HISTORIC AND DESIGN REVIEW COMMISSION

HDRC CASE NO: 2019-307
ADDRESS: 123 CROFTON
LEGAL DESCRIPTION: NCB 941 BLK 4 LOT E IRR 195 FT OF 10 & E IRR 182.1 FT OF N 1/2 OF 11
ZONING: RM-4,HS
CITY COUNCIL DIST.: 1
DISTRICT: King William Historic District
APPLICANT: John Chesser
OWNER: Linda Couch/NSHE TX DEVINE LLC
TYPE OF WORK: Front porch railings
APPLICATION RECEIVED: May 09, 2019
60-DAY REVIEW: July 08, 2019
CASE MANAGER: Adam Rajper
REQUEST:

The applicant is requesting a Certificate of Appropriateness for approval to add a balustrade to the existing front porch.

FRONT ELEVATION

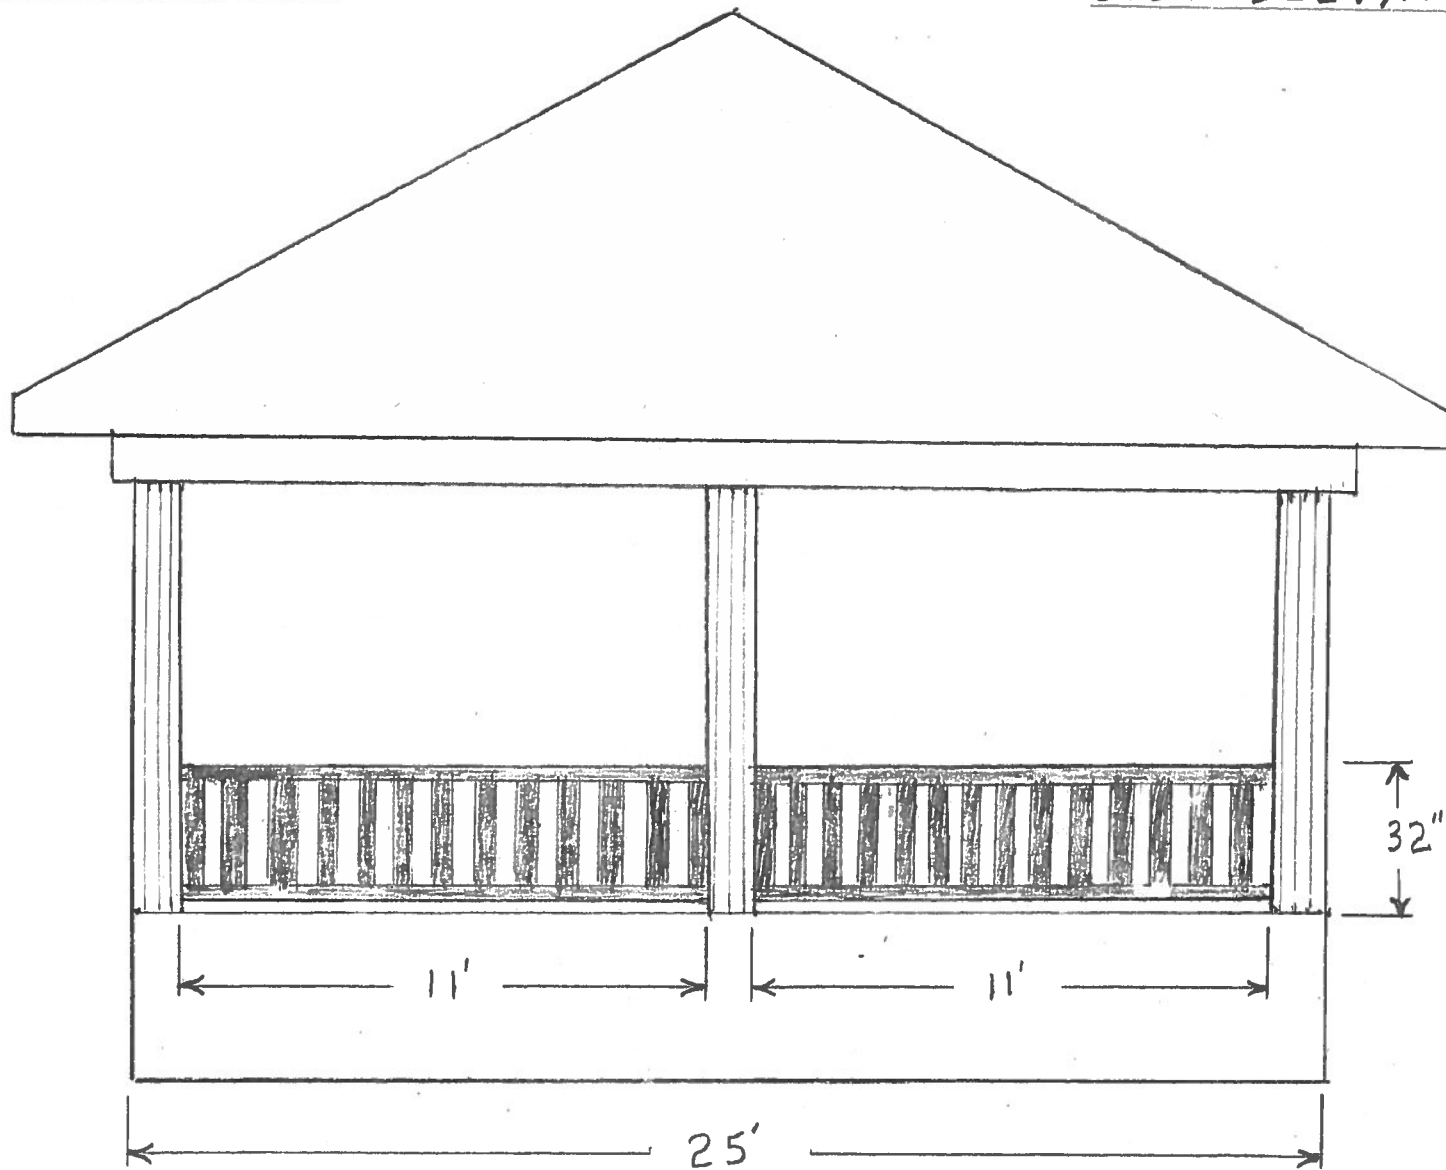
- c. **BALUSTRADE DESIGN** – The applicant has proposed to add a wood balustrade to the front porch. The applicant has also indicated that wood balusters with a Classical design will be incorporated, but has not provided baluster details. According to Guideline 7.B.iv for Exterior Maintenance and Alterations, new porch elements should be simple so as to not distract from the historic character of the building and create a false historic appearance. Staff finds that the proposed balustrade’s design is simple and appropriate for the Folk Victorian style of the home. Staff finds the proposal consistent with the Guidelines with the stipulations listed in the recommendation.

- i. That the applicant submit baluster details to staff for review and approval prior to receiving a Certificate of Appropriateness. This can include a drawing showing baluster dimensions or a sample of the baluster.
